Michael A. Berardi  
Director  
Service Engineering Operations  
Ford Customer Service Division

**SUBJECT: NEW VEHICLE DEMONSTRATION / DELIVERY HOLD - Safety Recall 17S36**  
Certain 2017 Model Year F-150 Vehicles with a 10R80 Transmission  
Transmission Roll Pin Replacement

**FIGURE 1**

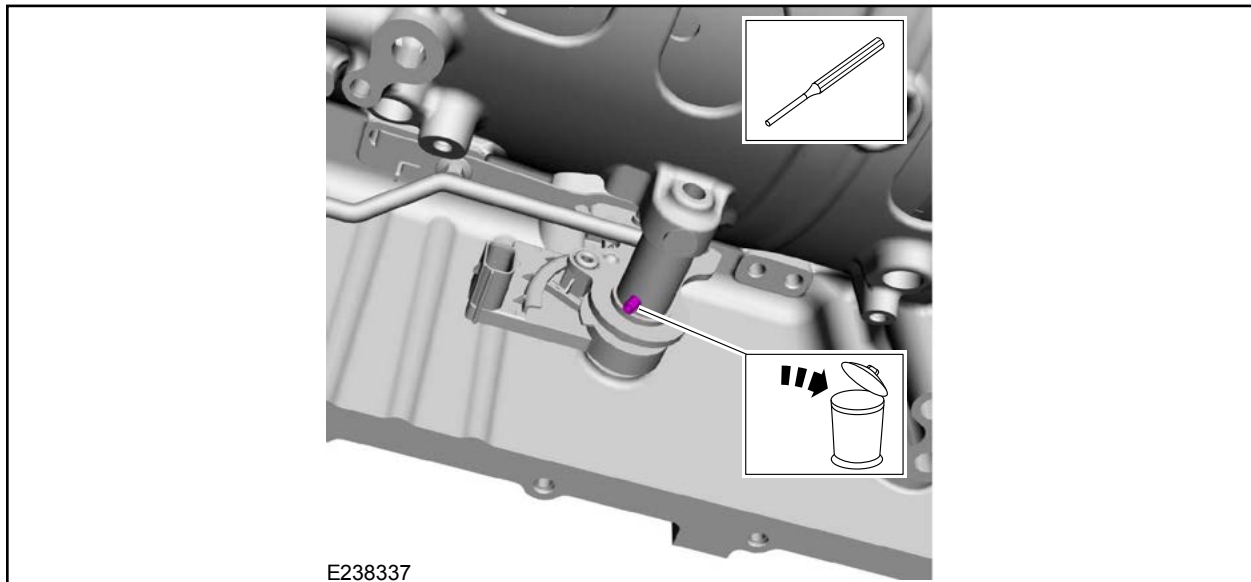
2. Replace the transmission manual control shaft-to-transmission range sensor roll pin. See Figure 1.

- When installing the new (revised) roll pin, insert tapered end first. Then drive the roll pin into the manual control lever shaft until 3 mm (0.11 in) of the roll pin remains out of the bottom of the shaft.

**NOTE:** Mark the new roll pin at 3 mm (0.11 in) up from the bottom (opposite the tapered end) to aid installation.
